Location:
7030 St Ives Blvd

Request
A variance request for a
side yard setback

Case Manager:
Lauren Coffman,
Associate Planner

Hudson Board of Zoning and Building Appeals	
April 17, 2025	DOCKET 2025-128

Site Plan
7030 St. Ives Boulevard
Hudson, Ohio

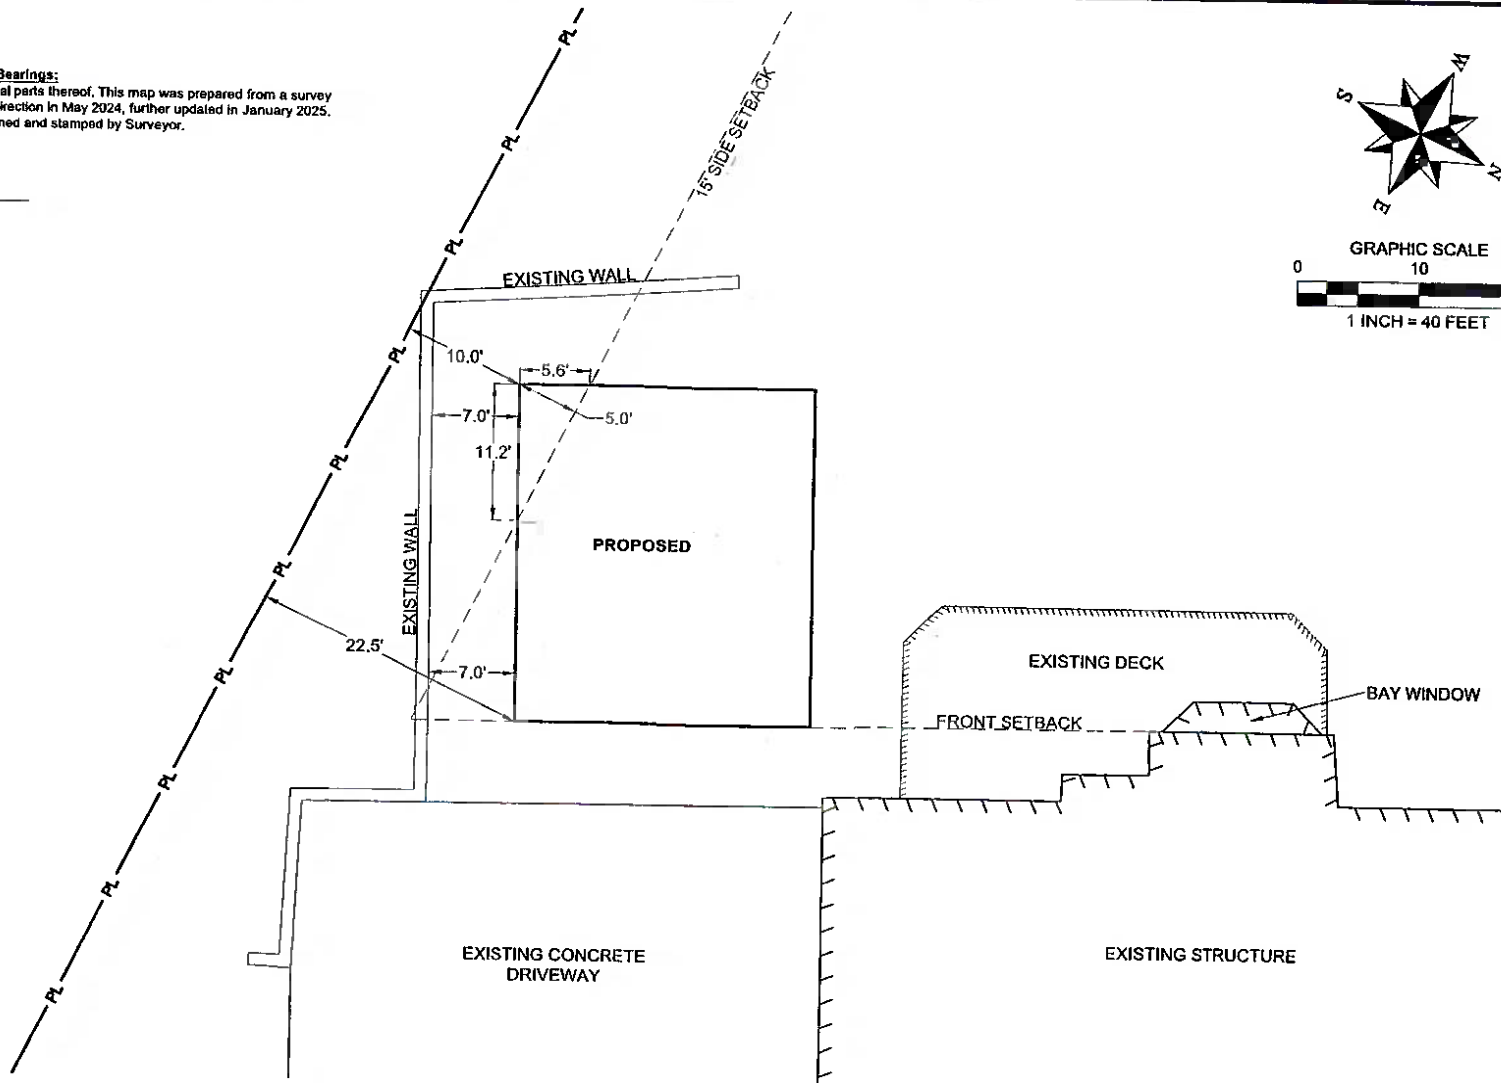
Staff notes that approximately 31 square feet of the total 672 sq. ft of the accessory structure is proposed to be located within the side yard setback.

Staff questions if the applicant could reduce the overall size of the proposed structure in order to meet all Land Development Code requirements. Additionally, staff questions if the garage could be sited further to the rear of the property and angled to increase the side yard setback. Staff notes the rear yard setback for accessory structures is fifteen (15) feet.
